**EB-2022-0111 Bobcaygeon Community Expansion Project Leave to Construct  
Pollution Probe Submission**

**Enbridge Gas Inc.  
Bobcaygeon Community Expansion  
Leave to Construct**

**POLLUTION PROBE SUBMISSION**

Figure 1: Pathways to Net Zero Emissions for Ontario <sup>48</sup>

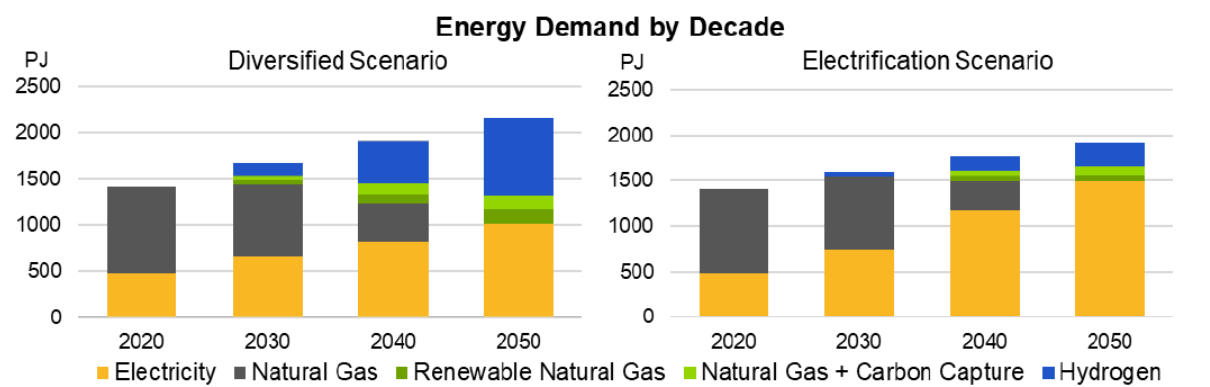
Enbridge recently commissions a study to identify a Diversified Scenario to provide a best-case scenario for natural gas infrastructure between now and 2050 given the Energy Transition to Net Zero emissions pathway in Ontario. If this Project is commissioned in 2025, it would require collection from ratepayers out to 2065 based on a 40 year amortization period<sup>46</sup> and the proposed System Expansion Surcharge proposed for this project. Even under Enbridge’s most optimistic Diversified Scenario all customers except potentially the largest industrial customer (if they can install carbon capture and sequestration or CCS) will no longer be using natural gas before the project is fully recovered. Enbridge has confirmed that this project has not been designed or approved for hydrogen<sup>47</sup>.
